# STAFF REPORT KETCHUM PLANNING AND ZONING COMMISSION REGULAR MEETING OF NOVEMBER 25, 2025

PROJECT: 140 & 180 N Leadville Ave ARCH Workforce Housing Project

APPLICATION TYPES: Design Review (Application File No. P25-033) & Lot

**REQUEST:** Final Design Review and Lot Consolidation Preliminary Plat

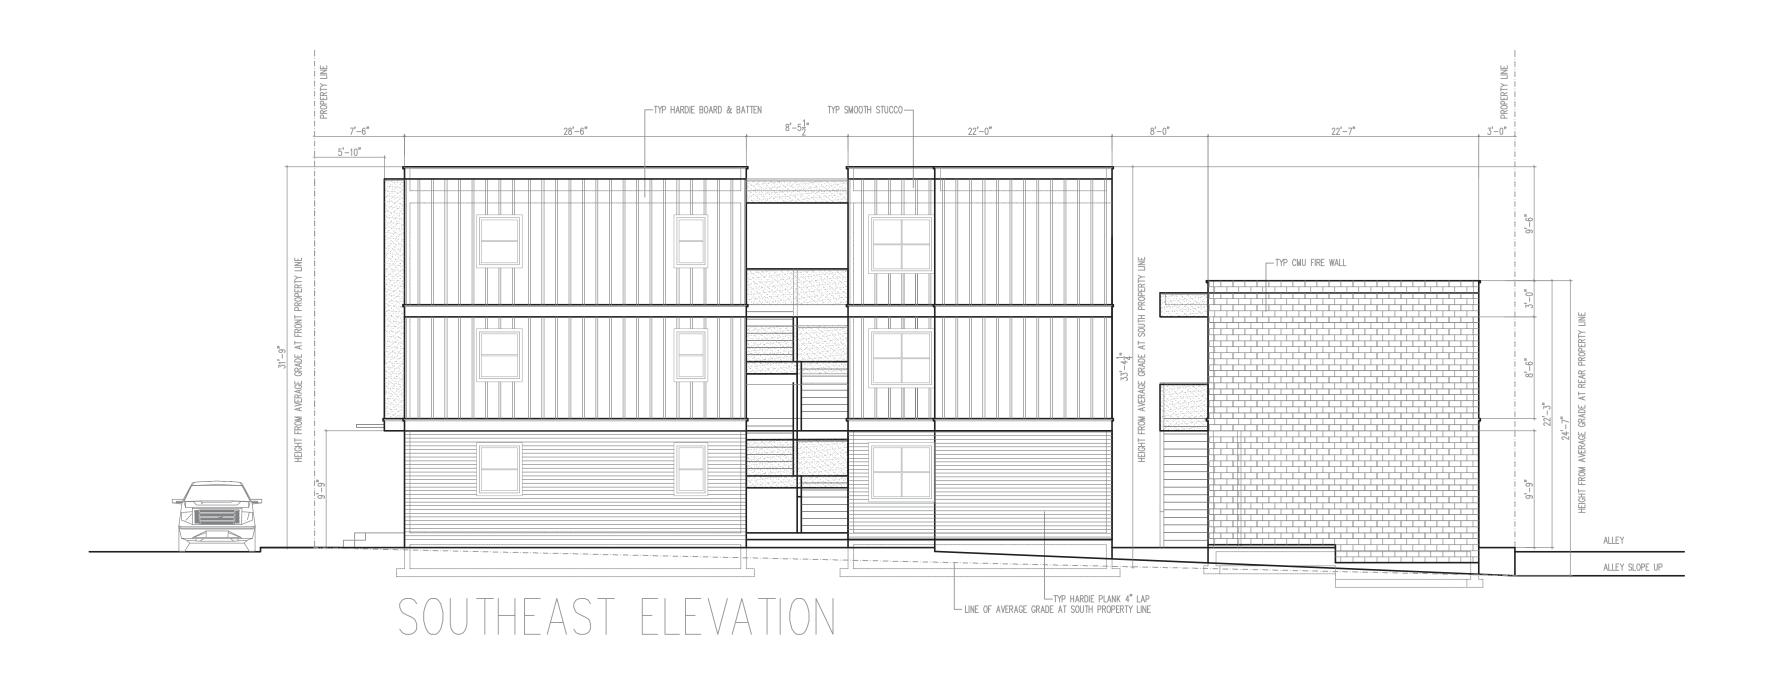
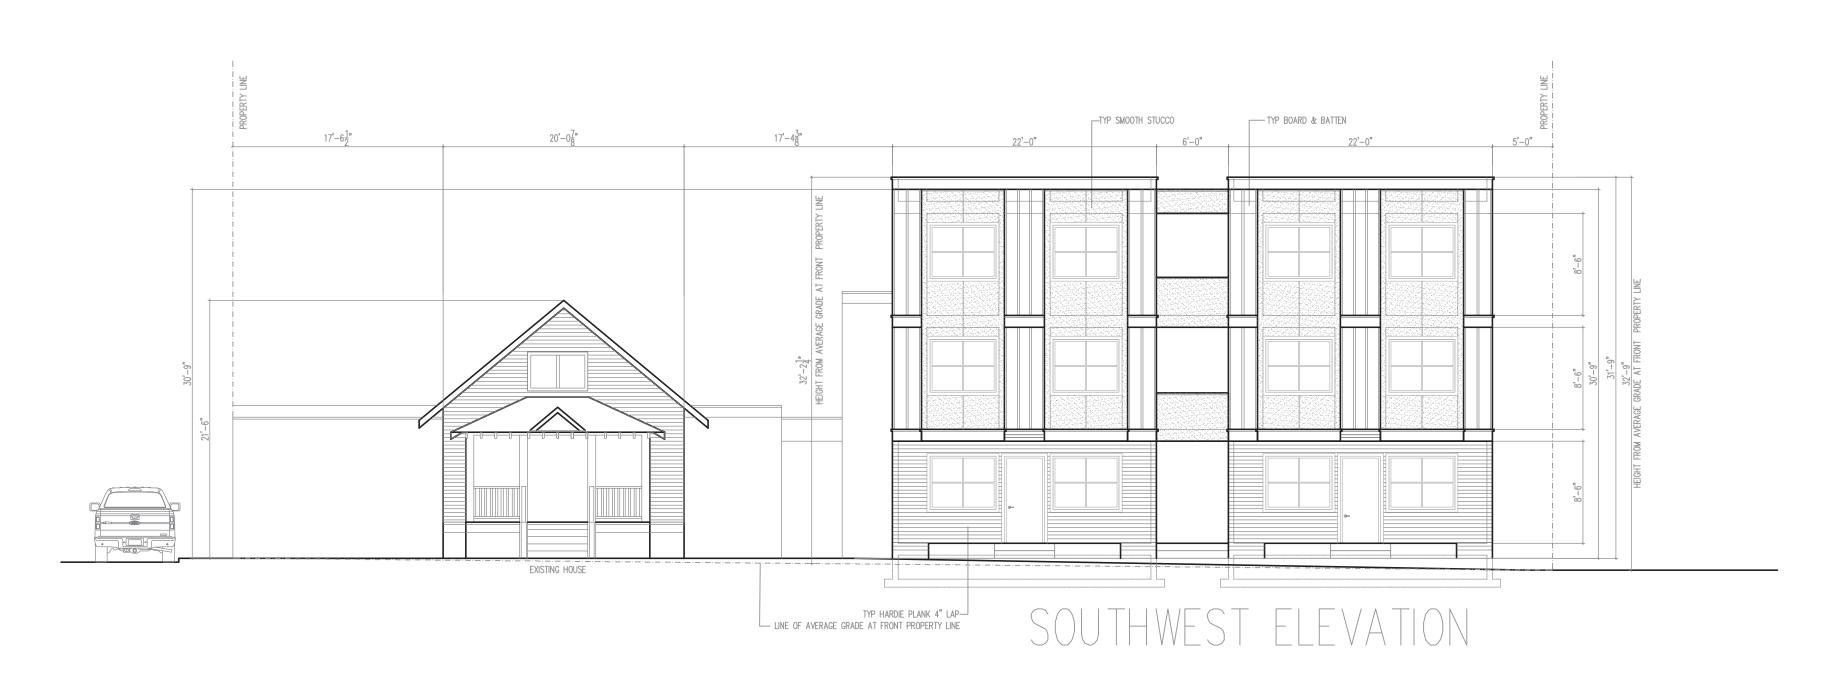
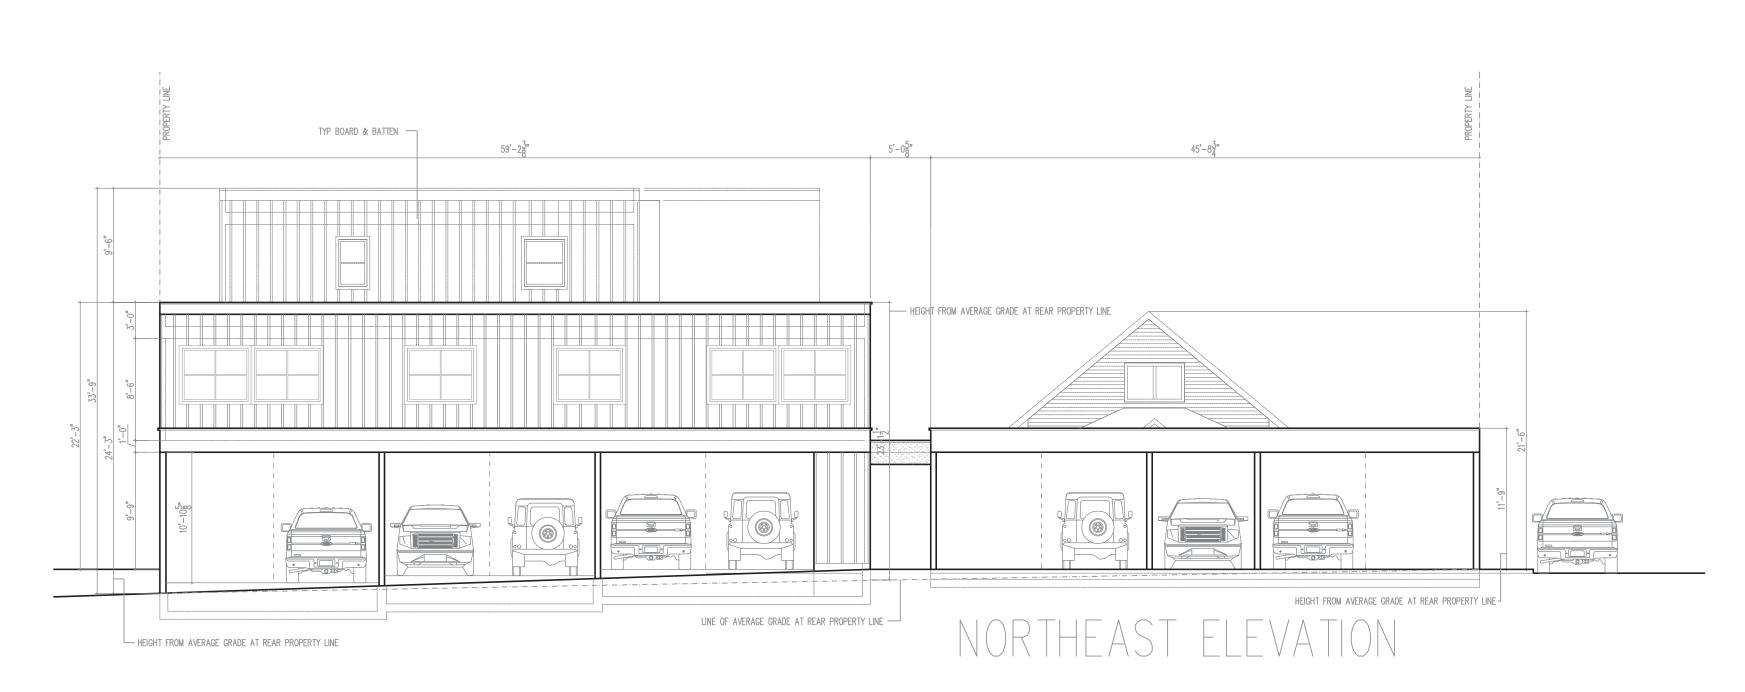
While the stucco projections add visual interest, staff is concerned about the large expanses of undifferentiated blank surfaces at the northwest elevation. The southeast and northwest facades have horizontally placed Hardie Plank siding on the ground floor and vertically placed Hardie Board & Batten siding on the upper floors. During city department review, Planning staff recommended the applicant further articulate and differentiate the southeast and northwest facades to add visual interest and reduce the appearance of bulk and flatness. Planning staff encouraged the applicant to consider building articulation features like contrasting material wainscot, decorative façade features, detailing, and further differentiating exterior materials and colors may help add visual interest and relief to building bulk and flatness.

Staff does not believe the material and color changes provide sufficient visual relief to the undifferentiated blank surface at the northwest elevation and recommends further articulating the northwest façade through cladding, materiality, color, and detailing that adds depth, texture, and visual interest. Sensitive to the applicant's desire to maintain affordability and not add unnecessary cost, staff does not recommend modulating the mass of the buildings but instead recommends enhancing visual interest through the creative use of exterior materials, colors, and details.

Pursuant to KMC 17.96.060.E1, "materials, colors and signing shall be complementary with the townscape, surrounding neighborhoods and adjoining structures." Staff is concerned that the black, gray, and beige colors appear stark and cold. The majority of the building walls are painted black and dark gray. Staff believes the expanses of undifferentiated black surfaces appear flat and monotonous. During city department review, Planning staff recommended the applicant reduce the building wall areas that are painted black and introduce warmer color tones into the exterior material and color palette. The applicant introduced a dark gray color for the upper levels of the residential buildings. Staff remains concerned that the expanses of undifferentiated black and dark gray color appear cold, stark, and monotonous.

Pursuant to KMC 17.96.070.B4, "Roofing forms and materials shall be compatible with the overall style and character of the structure." The proposed three-story residential buildings at the same height elevation. Staff is concerned flat roofline in conjunction with the continuous black/dark gray façades appear monotonous and lack character. Staff recommends the applicant consider adding depth and detail to the roof parapets to create and intentional façade termination that adds visual interest to the flat roof design.

To address staff commentary, we have decided to differentiate the color of the façade. We have chosen to keep the same color for anchoring the lowest floor sided with the 4" lap siding. The upper two floors died with the board-and-batten will now have a slightly lighter color setting off the visual relief for the facades in question. While revising the follow plans and buildings facades to introduce additional articulation and modulation may work for market rate housing, our mission is to design and construct these buildings most efficiently allowing for the greatest resultant affordability without adding unnecessary costs. In addition, the placement of trees and landscaping will greatly influence the one façade in question together with the views of the adjacent home. And finally, several adjacent buildings have recently been approved and constructed using a similar color that look great.

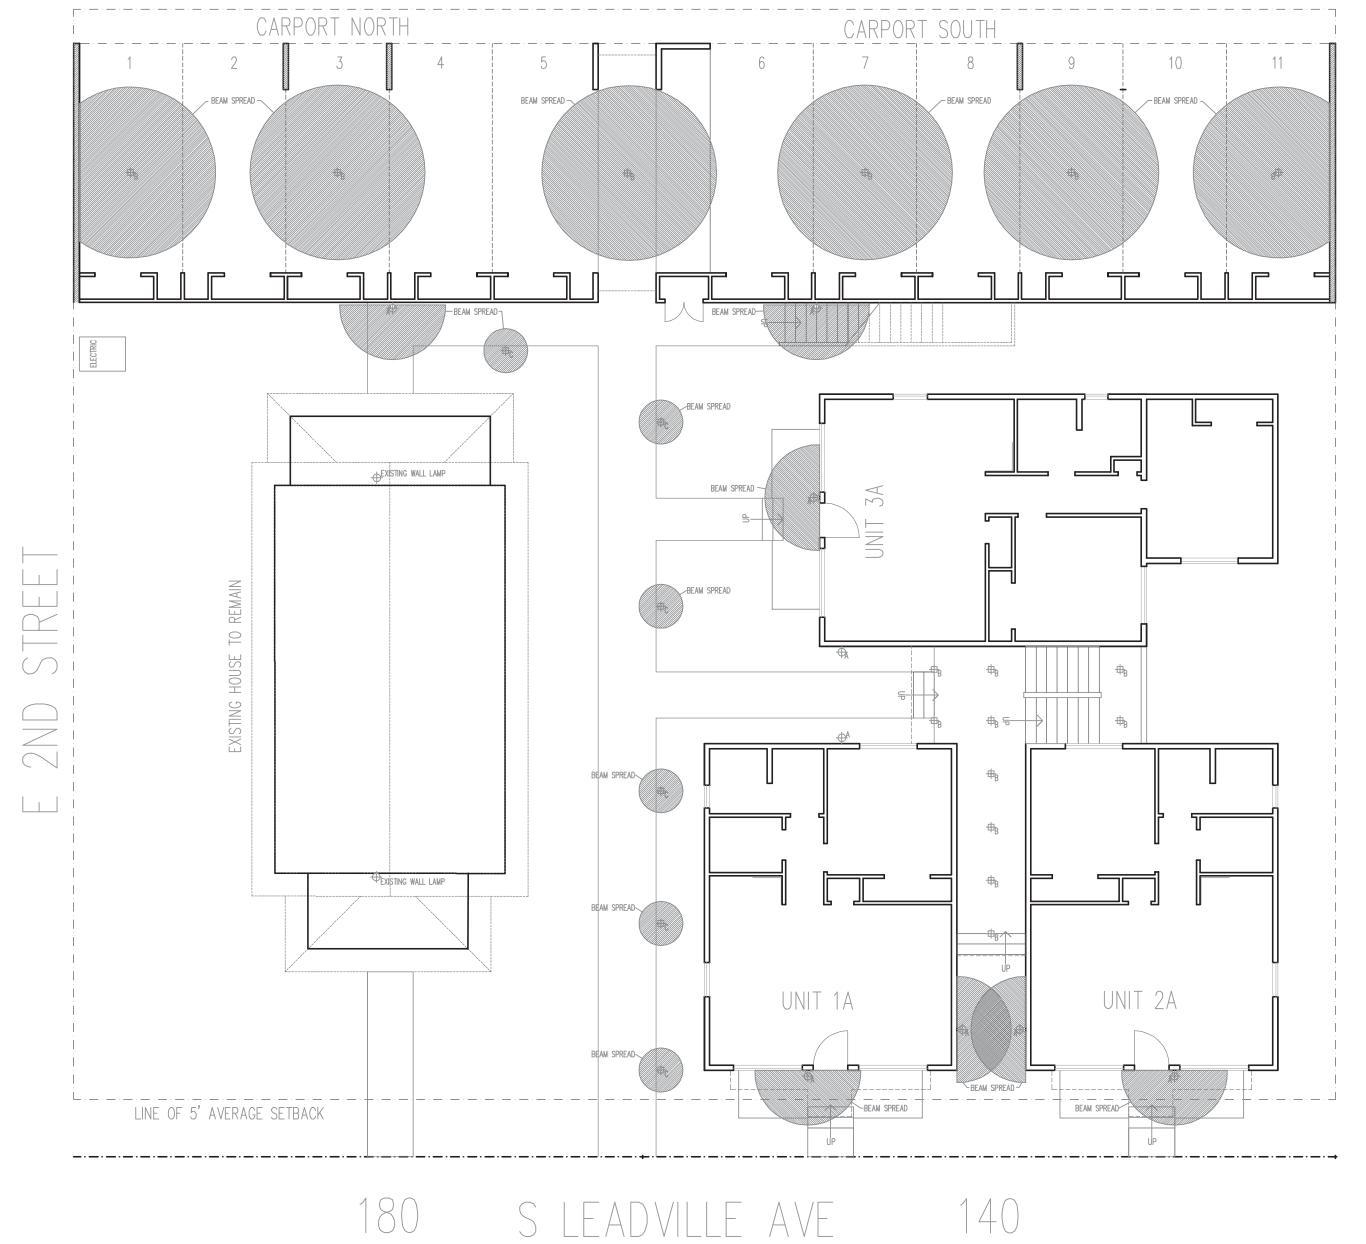
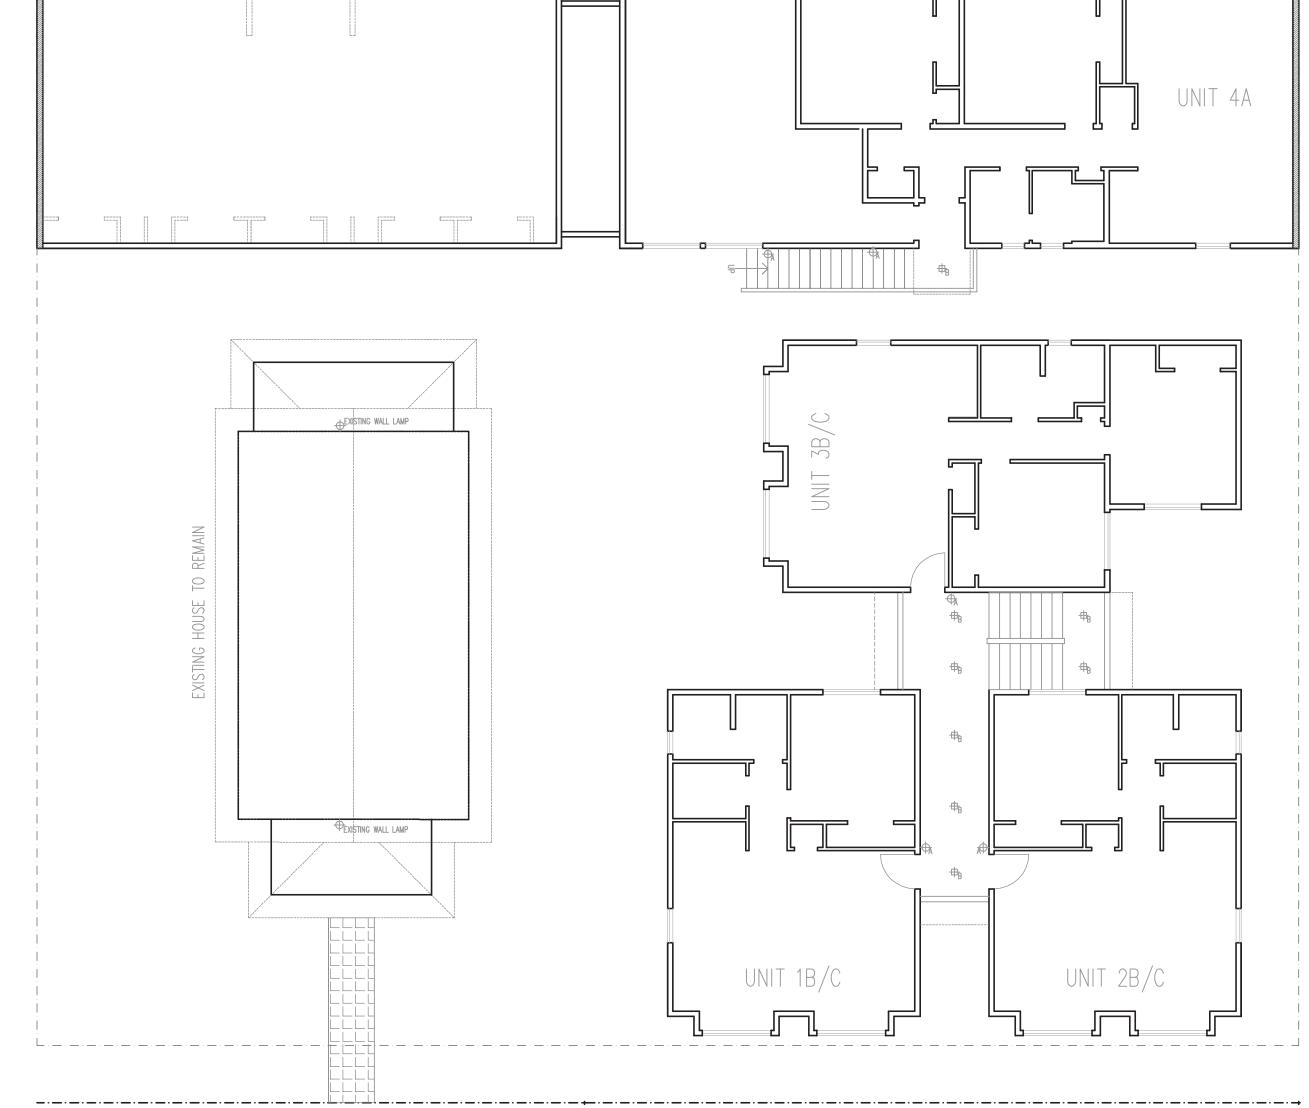
- Architect's Response: Please review the changes as suggested on pages A.3 and A.4.
- 3. <u>Comment</u>: Exterior Lighting—The exterior lighting specifications for the Design Classics Lighting LED Black Outside Wall Cylinder (A) and BEGA Pathway Bollard Luminaire (C) on sheet E.2 indicate that the color temperature is 3000K. Pursuant to KMC 17.132.030.A. Color Temperature, "All exterior lighting shall utilize light sources not to exceed 2700 Kelvin." The Design Classics Lighting LED Black Outside Wall Cylinder and the BEGA Pathway Bollard Luminaire exceeds the maximum color temperature permitted per KMC 17.132.030.A.

- Required Action: Please either: (a) select different exterior lighting fixtures that have
    a color temperature that does not exceed 2700K and provide the new specifications
    on sheet E.2 or (b) verify that a different light source with a color temperature that
    does not exceed 2700K can be installed in the fixtures and add a note to the
    specifications on sheet E.2.

- 4. <u>Comment</u>: Exterior Lighting—The NUWATT 4" Black Square Anti-Glare Warm LED Recessed Can (B) exterior lighting specification on sheet E.2 notes that the color temperature ranges from 2700K to 5000K.

- <u>Required Action</u>: Please revise the specification for the NUWATT Can exterior lighting fixture on sheet E.2 to specify that the light source will be 2700K.

- Architect's Response: We have chosen a new bollard specification, see sheet E3. The new fixture, a WAC Lighting Ledge LED path light 6801, 2700K is Dark Sky approved. See note on E2, depicting the beam spread of each outside lighting fixture, and about
